Zoning Board of Appeals January 27, 2021 Regular Meeting

STAFF REPORT

Subject: ZBA 20-035; 416 West Huron

overall landscape plan SCALE: 1" = 30'-0"

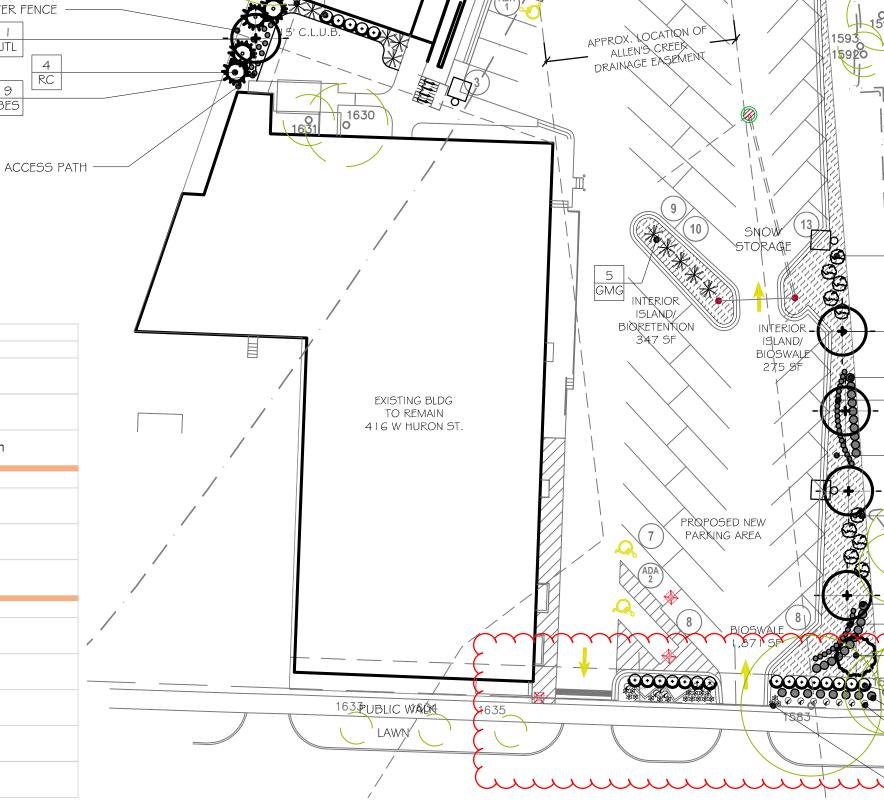
The WCWRC prohibits planting of trees directly over the storm drain or within that easement. While the petitioner will be providing the required area for interior landscape islands and the buffer area along Huron, there will be no trees planted.

The zoning variance is being requested to address the code requirement for street tree plantings. The subject site requires five street trees and three are currently existing and will remain. The variance request would cover the requirement for the additional two trees

required. These trees are not able to be planted due to the location of the Allen Creek Drain.

• 1 tree/30'vehicular use area required. 89' of vehicular use area facing the ROW/30'= 3 trees required. One existing. Additional trees cannot be planted in this area due to easement and floodway restrictions; a landscape modification will be requested for the

• 1 required for every 45' of street frontage. 185' of street frontage/45 = 5 trees. 3 existing, sufficient for 135' frontage. Owner will request landscape modification of two trees due to
